SUBJECT: Windshield Wiper Inoperative - One or Both Stages Failed

MODEL: 5 Series (E39), 7 Series (E38)

E38 Relays K36 (1) and K37 (2) in engine compartment, at bottom of E-Box

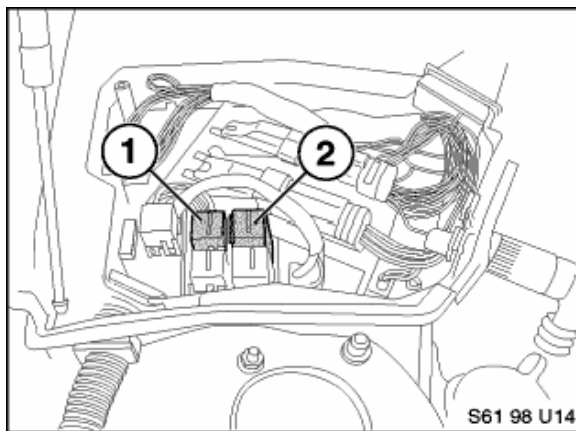
Procedure: If a defective relay is suspected, locate wiper relay(s)

Correction: Replace the defective relay with improved relay with new part number.

Use Relay Test Tool 61 3 010 to confirm if a relay is defective, and replace if necessary.

E39 to 8/97 Relays K36 (2) and K37 (1) in engine compartment E-Box

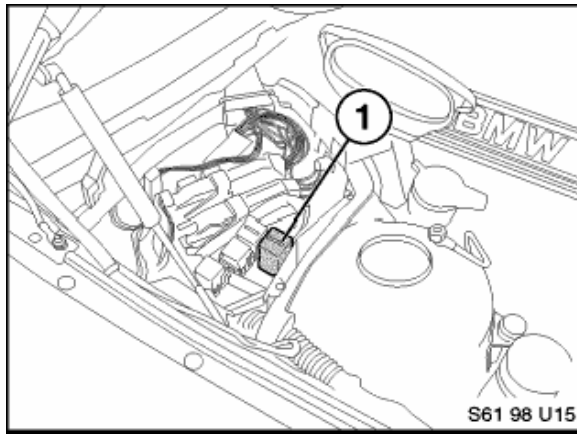
E39 from 9/97 Relay K11 (1) in engine compartment E-Box.
